ERL Consensus Discussion

For the purpose of closing comments on Draft 1.2

IEEE 802.3 100 Gb/s, 200 Gb/s, and 400 Gb/s Electrical Interfaces Task Force

COM vs ERL using Varying Eta_0 Values

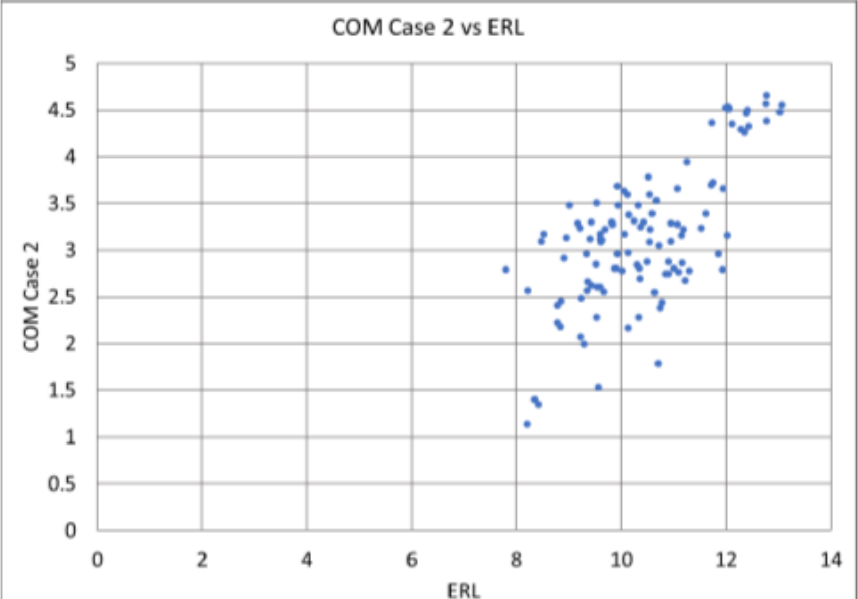
- Plot on right shows COM vs ERL for 110 channels
- Min ERL is 8.7
- A min ERL of 8 is recommended for specification to allow room to limit for other forms factors in addition to cable assembly and connector variation

- Proposed Accept
